ADDENDUM NO. 2

DATE: May 24, 2024

Request for Bids Specification No. ES24-056F

Foss Shoreline Restoration Outfall 230A Repair Project

CITY OF TACOMA
ENVIRONMENTAL SERVICES DEPARTMENT
FOSS SHORELINE RESTORATION - OUTFALL 230A REPAIR PROJECT
FOSS SHORELINE RESTORATION PLAN

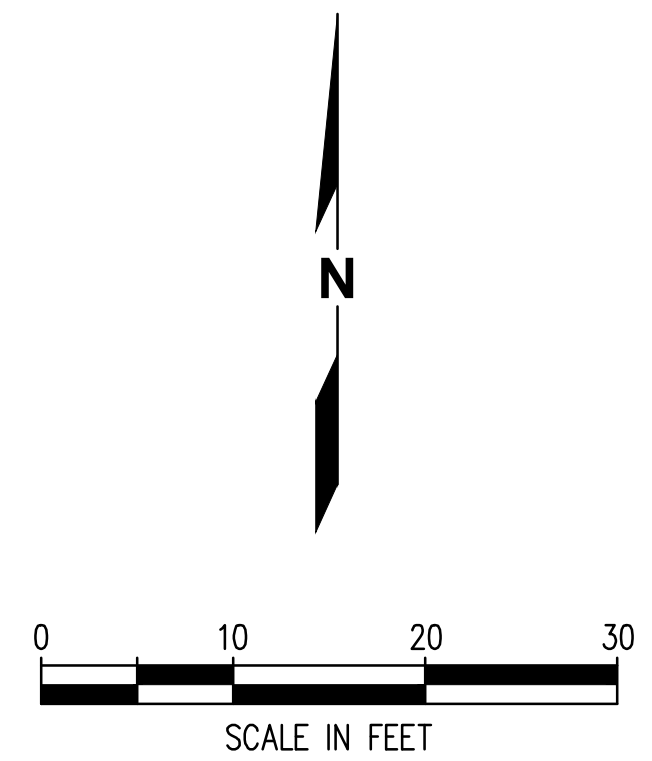
Revision 1: Note 5 on Plan Sheet 3 has been revised to remove coordination with City Maintenance Crews for assistance with the bypass pumping system. See attached revised project plans.

5. CONTRACTOR SHALL CONSTRUCT A TEMPORARY BYPASS SYSTEM TO CONTROL AND MAINTAIN STORM DRAIN FLOW DURING CONSTRUCTION.
6. THE TEMPORARY BYPASS SYSTEM MUST BE DESIGNED FOR EXPECTED FLOWS. SEE SPECIFICATIONS FOR FLOW CRITERIA.

CITY OF TACOMA
ENVIRONMENTAL SERVICES DEPARTMENT
FOSS SHORELINE RESTORATION - OUTFALL 230A REPAIR PROJECT
STORMWATER OUTFALL SECTION

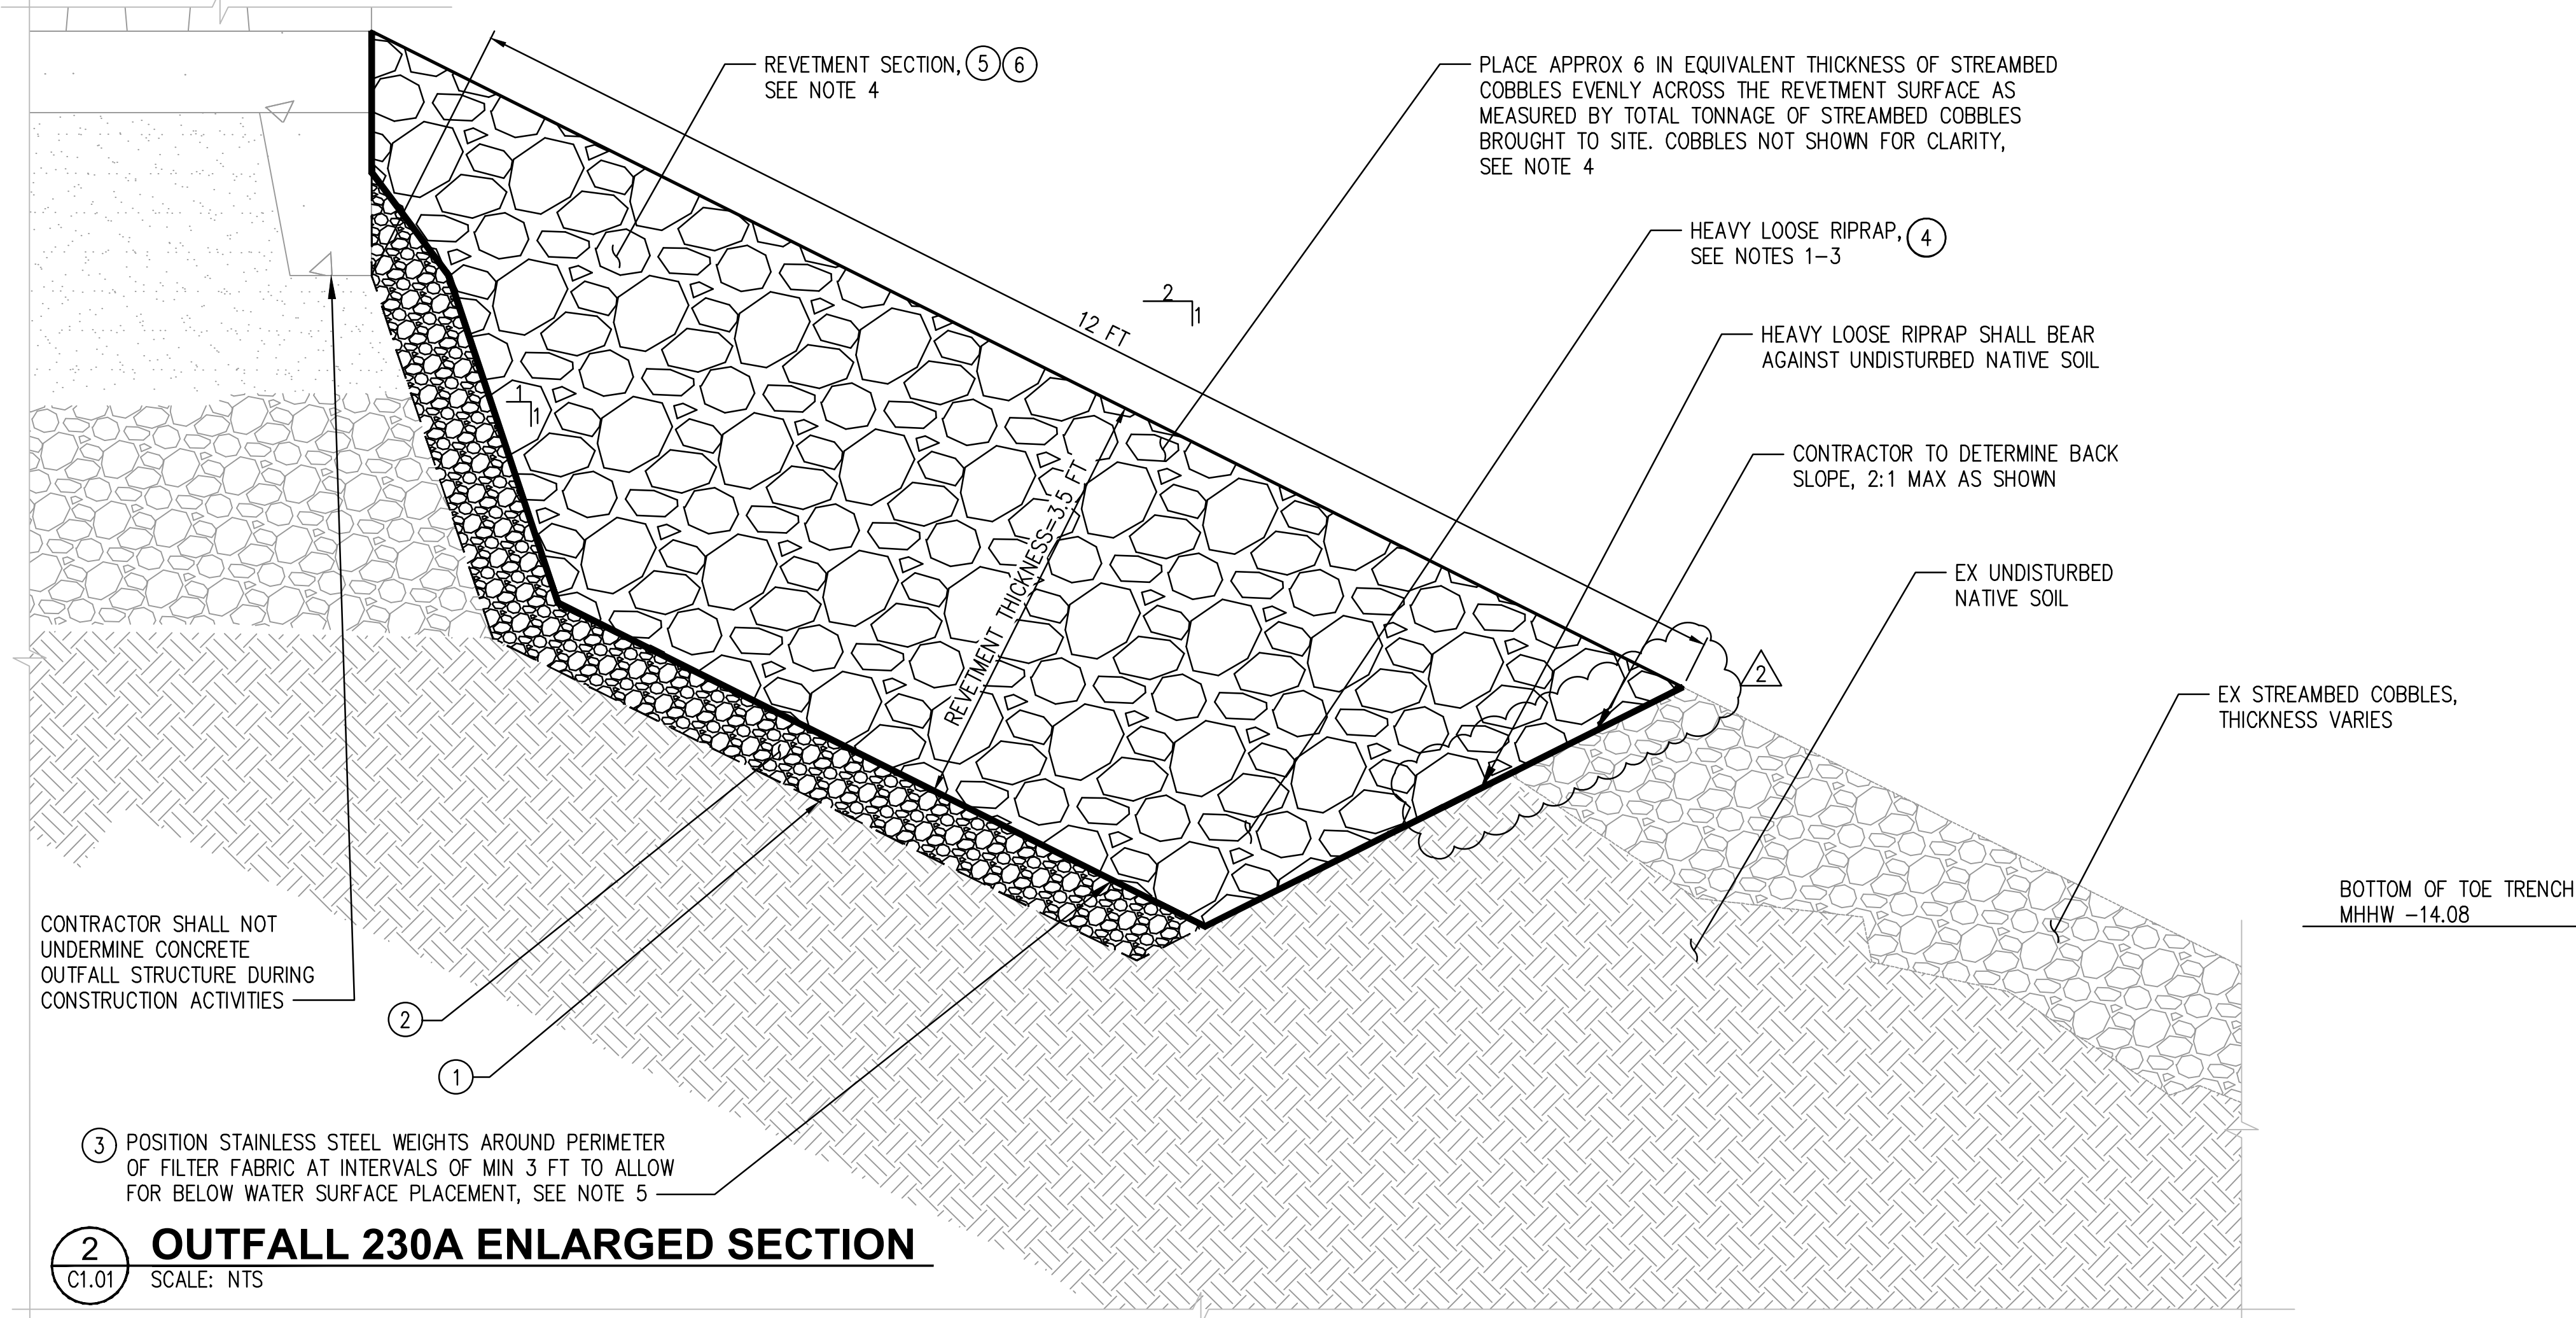
Revision 2: Note 5 on Plan Sheet 4 has been revised to indicate the filter fabric overlap is 3 feet. See attached revised project plans.

- NOTES**
1. HEAVY LOOSE RIPRAP SHALL BE A MEDIAN NOMINAL DIAMETER OF 28 INCHES WITH 50-80% PASSING SMALLER, SEE SPECIFICATIONS. HEAVY LOOSE RIPRAP SHALL BE VISUALLY ACCEPTED BY THE ENGINEER.
 2. HEAVY LOOSE RIPRAP SHALL BE HARD AND ANGULAR AND OF SUCH QUALITY THAT IT WILL NOT DISINTEGRATE ON EXPOSURE TO WATER OR WEATHERING AND SHALL BE SUITABLE IN ALL RESPECTS FOR THE PURPOSE INTENDED.
 3. THE USE OF RECYCLED MATERIALS IS NOT PERMITTED FOR THIS APPLICATION.
 4. TOP OF REVETMENT SHALL MATCH EXISTING GRADE. CONTRACTOR SHALL VISUALLY INSPECT REVETMENT SURFACE TO CONFIRM VOIDS ARE COMPLETELY FILLED WITH STREAMBED COBBLES. CONTRACTOR SHALL CONFER WITH THE ENGINEER AND THE CITY OF TACOMA FOR FINAL VERIFICATION.
 5. CONTRACTOR SHALL UNROLL FILTER FABRIC DOWNSLOPE, OVERLAPPING ADJACENT ROLLS A MINIMUM OF 3 FEET.

Revision 3: Detail 2 on Plan Sheet 4 has been revised to remove the filter fabric key into the native material. See attached revised project plans.
